This insert is written to supplement the Instruction Manual furnished with this modified instrument. The information given in this insert will supersede that given in the manual.

## TYPE 321 MOD 799F

The oscilloscope for which this insert was prepared has been modified to increase its vertical sensitivity by a factor of two, giving a 1--2.5--5 Vertical Attenuator sequence; the .1 SEC/DIV sweep rate has been deleted; and a 1 SEC/DIV rate has been added.

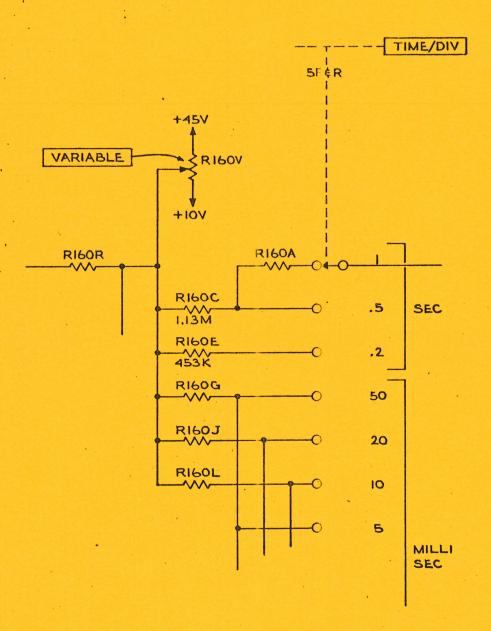
#### CAPACITORS

C506-S	Add	281-513	27 pf	Cer	500v	20%		
C507	Change to	281-605	200pf	Cer	500v			
RESISTORS								
R160C	Change to Change to Change to Change to Change to	318-021	1.13M	Prec	1/8w	1%		
R160E		318-022	453K	Prec	1/8w	1%		
R507		315-121	120Ω	Comp	1/4w	5%		
R508		316-680	68Ω	Comp	1/4w	10%		
R888		323-037	23.7Ω	Prec	1/2w	1%
